Re: Part VIII Planning Report for the construction of 18 new residential units at Cliona Park, Moyross.

**PLANNING REPORT IN ACCORDANCE WITH
SECTION 179 3(a) OF THE PLANNING & DEVELOPMENT
ACT 2000 - 2015**

Planning Reference No. 16/8010

Appendix 6: Recommended Alternative Site Layout Plan

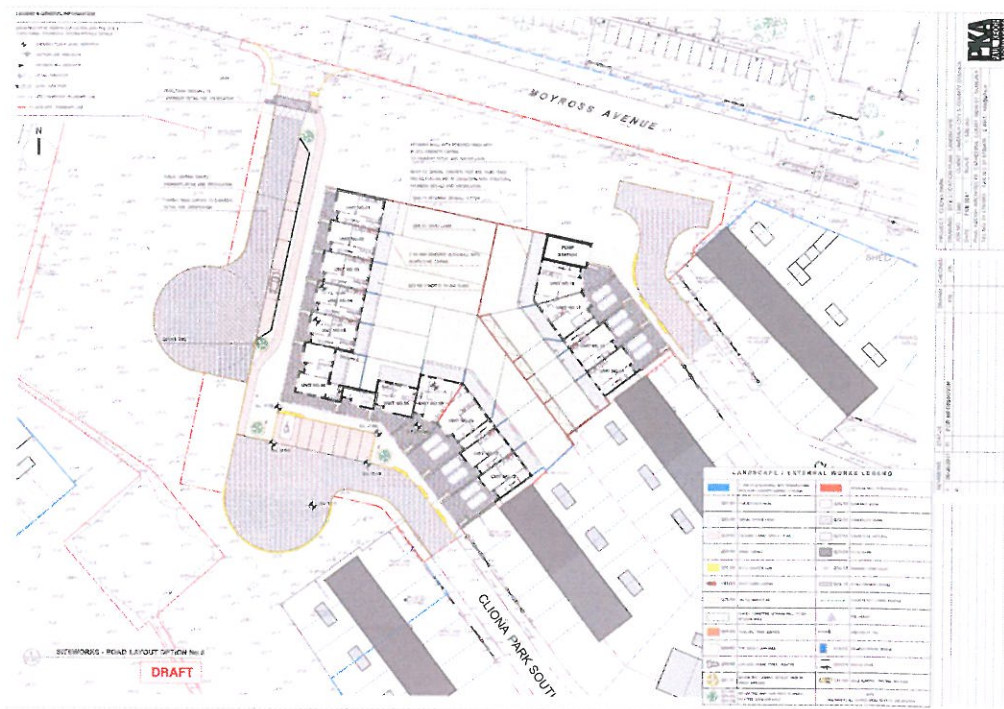
1. Converting existing cul-de-sacs within Cliona Park into through roads is objected to on the grounds of increased through traffic flow and activity impacting safe use and enjoyment of the existing street.

Arising from the consultation processes, the opening up of existing cul-de-sacs within Cliona Park is a key area of concern arising from perception that these new streets will generate new through traffic flows in their capacity as alternatives to existing routes. To alleviate this concern, design & Delivery Services recommends disconnecting envisaged through streets in the short term pending further development which will serve to disperse the feared concentrated burden of additional traffic movements on new streets across a broader network. An alternative recommended road network proposal is included at appendix 6.

It is recommended that a proposed condition is attached to any decision to grant permission in relation to this alternative road layout.
